RESPONSE TO SUBMISSIONS

4 Administrative Revision of Environmental Impact Statement (Section 3.1.2)

Administrative correction is required to some detail contained in Section 3.1.2, Table 3-2, and Figure 3-3 of the Environmental Impact Statement (EIS) for this project regarding subdivision, due to some recent legal advice received by the Proponent. The changes concern the approach to subdivision of land required by the project and are very minor in nature. The text requiring amendment is the third paragraph of the EIS Section 3.1.2, which should be amended as demonstrated below (superseded text formatted with 'strikethrough' and new text shown in blue).

Figure 4.1 New Lots Created by the Project

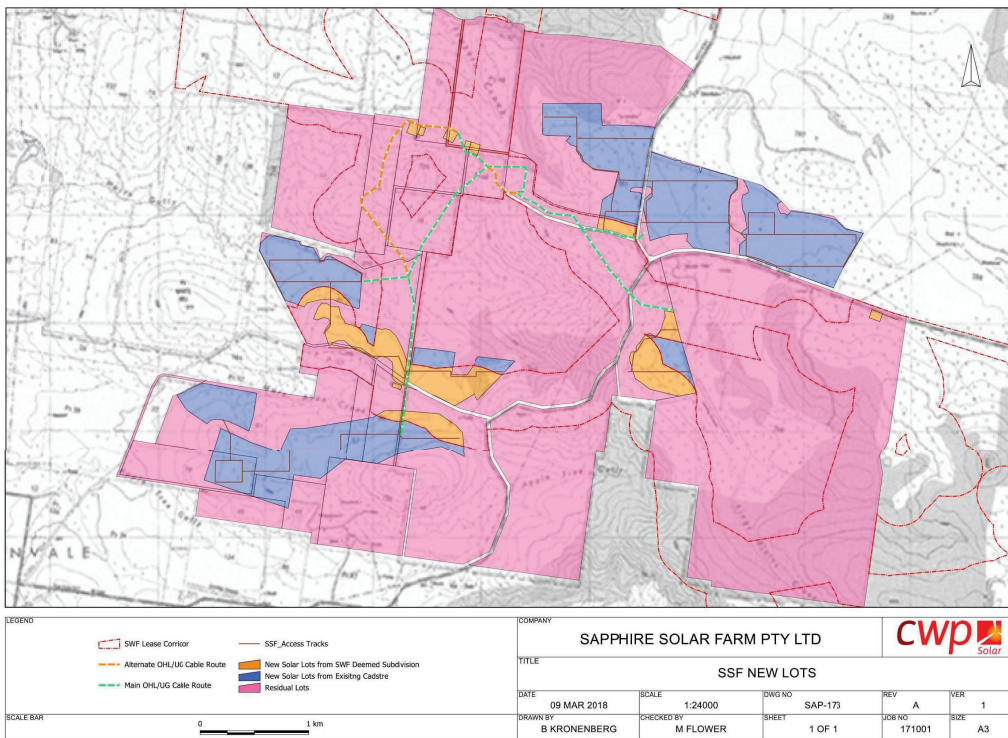
Some lots created as part of the Sapphire Wind Farm will be used as part of the Proposed Development ~~and as such, additional subdivision of these lots is not required.~~ For some of those SWF lots, they will now need to be the subject of a concurrent lease over only part of that SWF lot. Accordingly, additional subdivision of some of these lots will be required.

A revised table is presented (Table 4.1) which should replace Table 3-2 in the EIS, with Figure 4.1 below replacing 3-3 in the EIS.
